RE: Central Florida Power Limited Partnership,  
Tiger Bay Cogeneration Plant (PSD-FL-190)

RE: Central Florida Power Limited Partnership (CFPLP)  
Tiger Bay Cogeneration Plant  
AC 53-214903; PSD-FL-190

Re: Central Florida Power Limited Partnership  
Tiger Bay Cogeneration Plant  
PSD-FL-190  
AC 53-214903

Re: Central Florida Power Limited Partnership  
Tiger Bay (formerly Central Florida) cogeneration plant  
PSD-FL-190  
AC 53-214903

DWG. NO. 00232

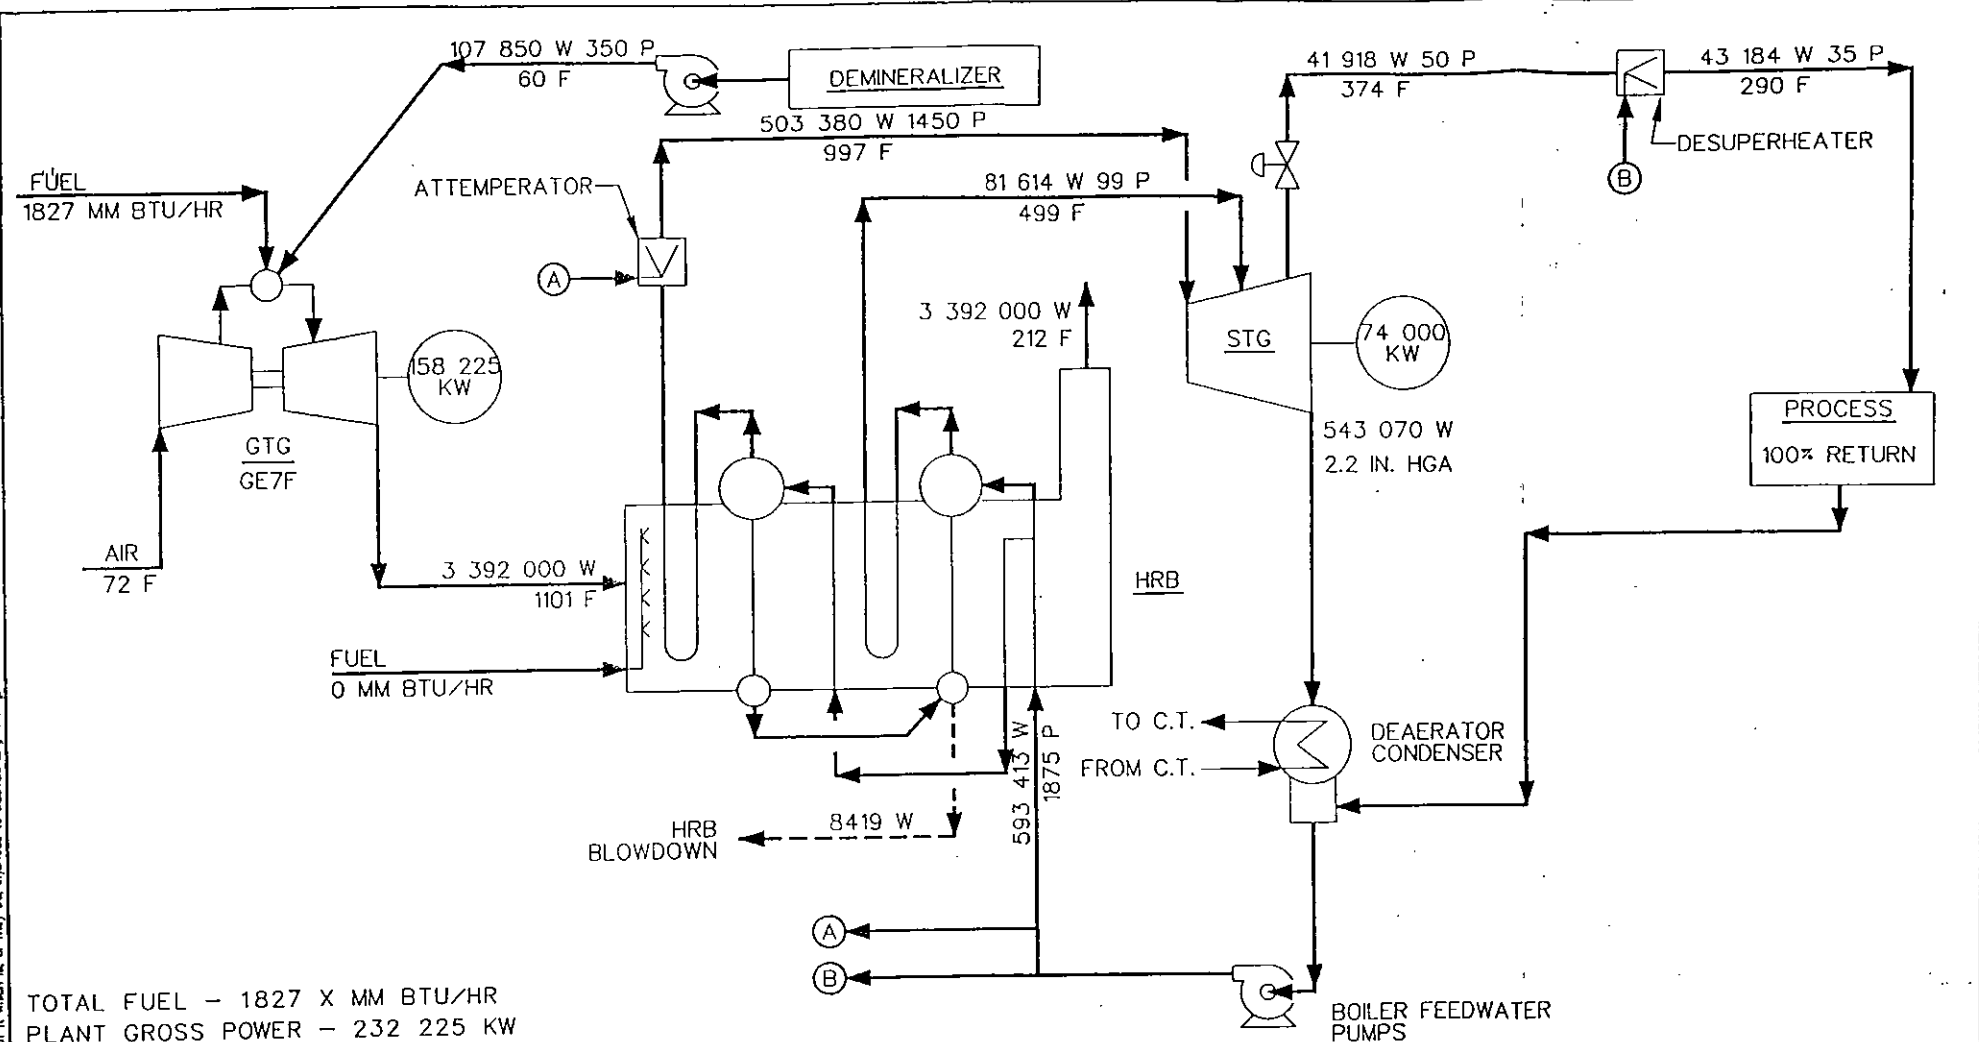
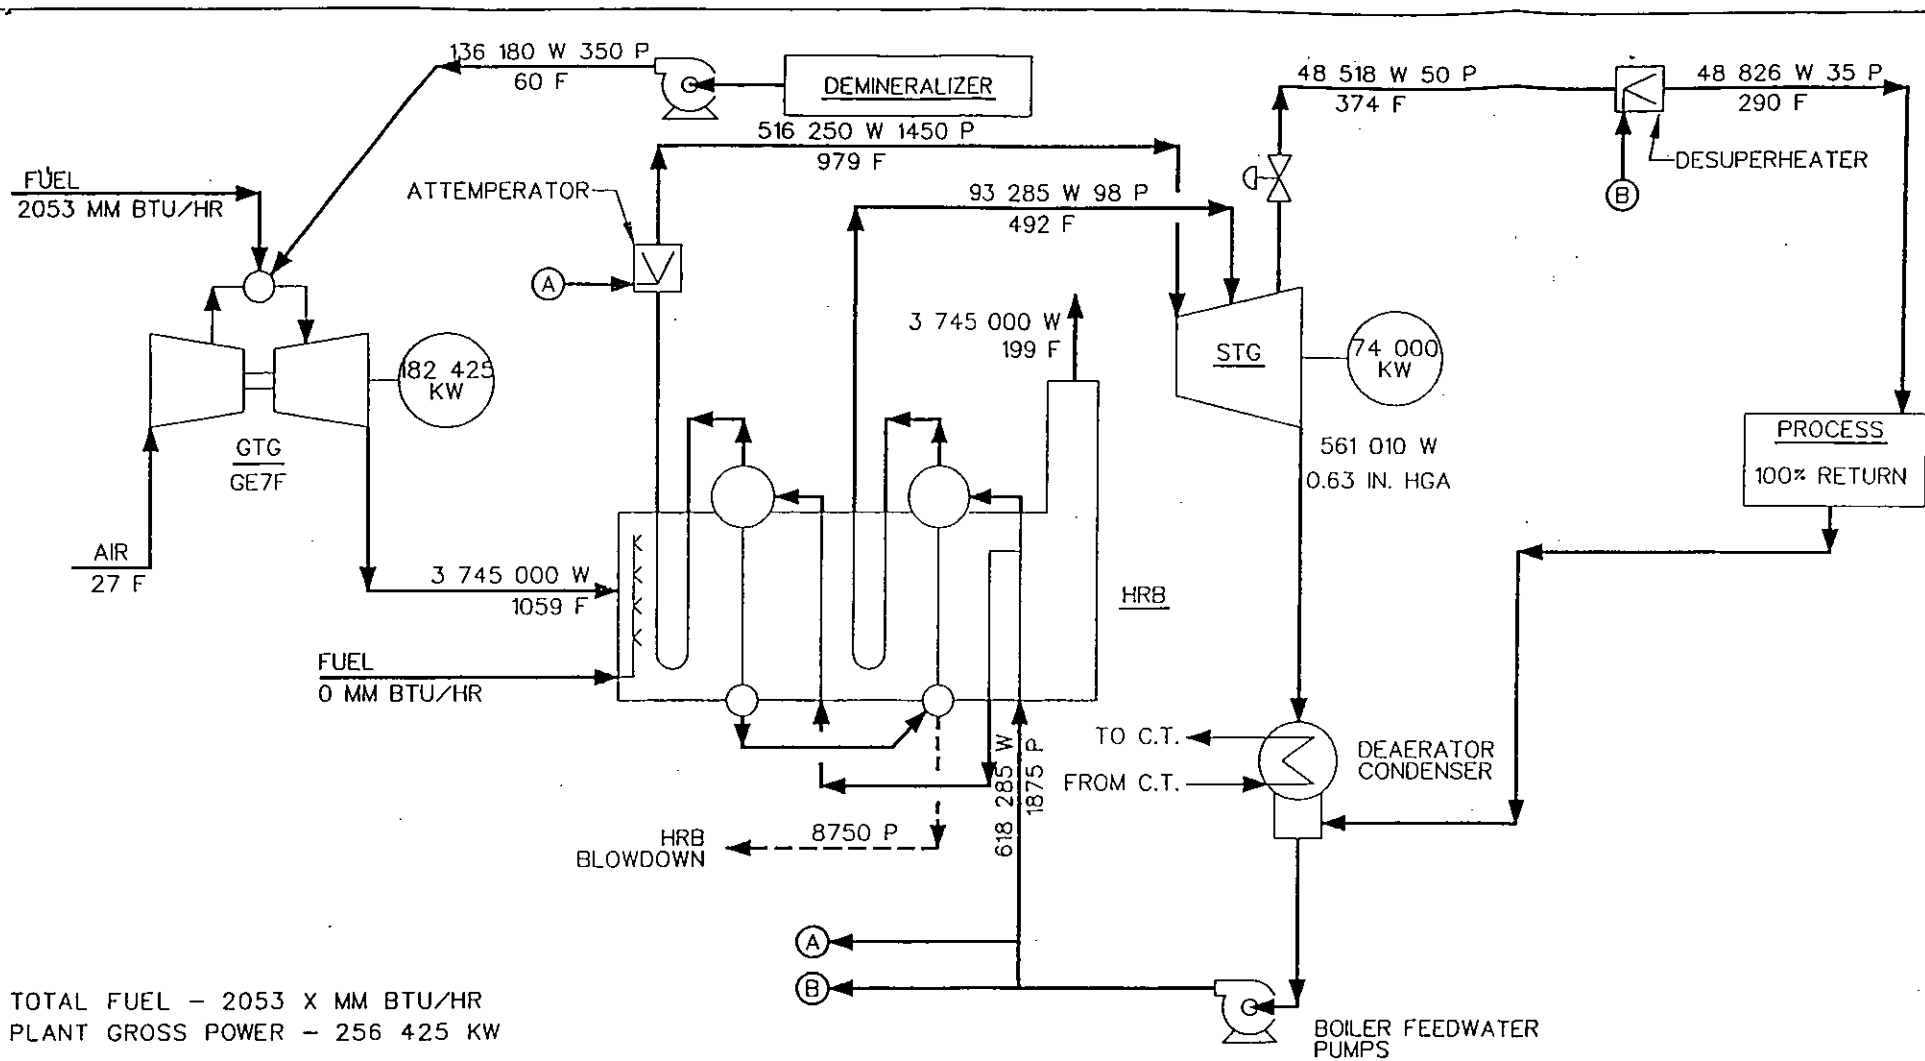
4. **COMMENT:** Submit an updated process flow diagram showing steam turbine and volumetric air flow rates.

**RESPONSE:** Updated process flow diagrams showing the steam turbine and the mass energy balance around the steam turbine and gas turbine are presented in Attachment 3 for natural gas and fuel oil firing.
